### 159. Physical Medium Dependent (PMD) sublayer and medium, types 25GBASE-BLR, 25GBASE-BMR, and 25GBASE-BER

Figure 159-2—Block diagram for 25GBASE-BxR transmit/receive paths

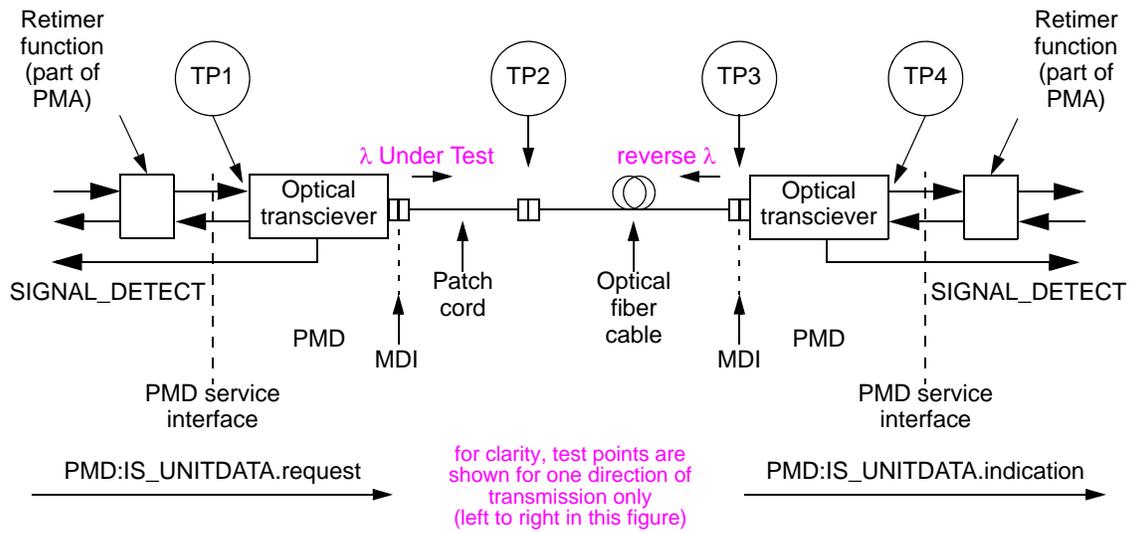
Editor's Note: If needed a referenced to PMD Table can be added to clarify " $\lambda$  Under Test"
